SIB 61 13 21

RECALL 20V-601: HIGH-VOLTAGE BATTERY RECALL

This Service Information Bulletin (Revision 3) replaces SI B61 13 21 **dated January 2022**.

- Claim Information Corrected

SP44 HV Battery (G05) modules-

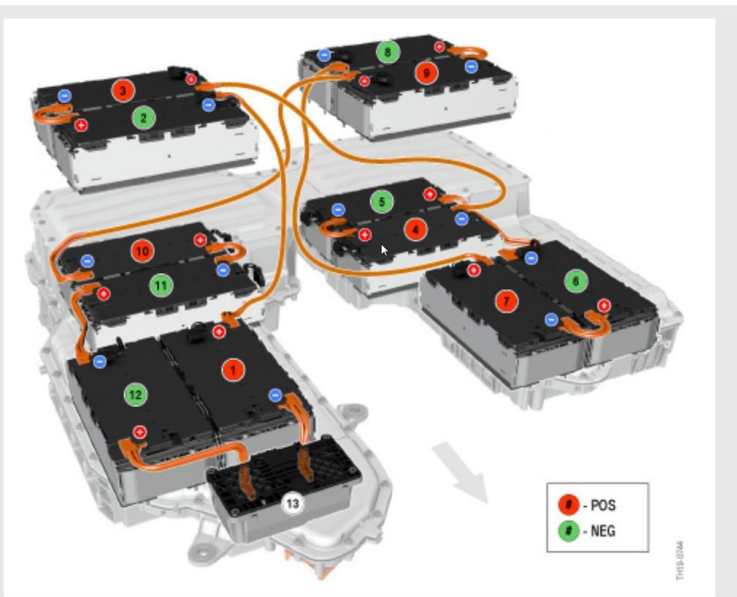
Modules are designed as Positive and Negative modules (with different orientation and part numbers). When replacing modules, verify in EPC the correct part (POS/NEG) and reinstall according to their original position. See below.

Use EPC diagram to verify the correct module part number (01/02) for NEG or POS modules.

Use the illustration on the right to match the part# with the correct module installation location.

- Module 12 is **NEG (01)**
- Module 1 is **POS (02)**
- Module 11 is **NEG (01)**
- Module 10 is **POS (02)**
- Module 2 is **NEG (01)**
- Module 3 is **POS (02)**
- Module 8 is **NEG (01)**
- Module 9 is **POS (02)**
- Module 5 is **NEG (01)**
- Module 4 is **POS (02)**
- Module 6 is **NEG (01)**
- Module 7 is **POS (02)**

SP41 HV Battery (G01/G20/G20/G12) modules-

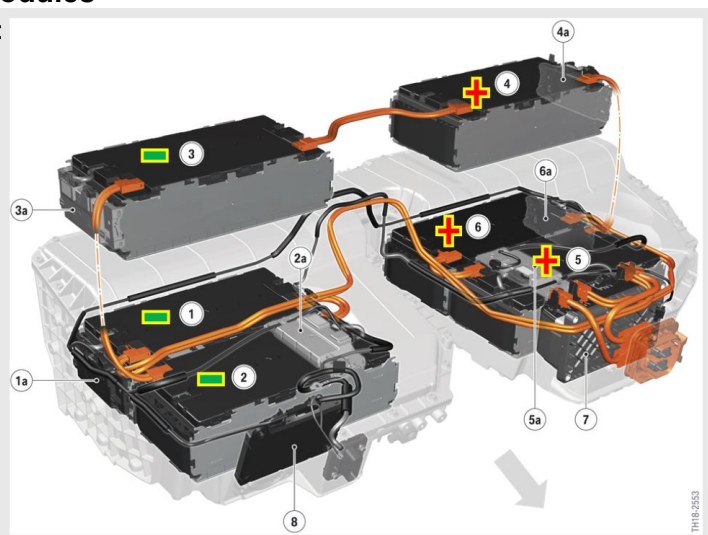
Use EPC diagram to verify the correct module part number (01/02) for NEG or POS modules.

Use the illustration on the right to match the part# with the correct module installation location.

- Module 1 is **NEG (01)**
- Module 2 is **NEG (01)**
- Module 3 is **NEG (01)**
- Module 4 is **POS (02)**
- Module 5 is **POS (02)**
- Module 6 is **POS (02)**
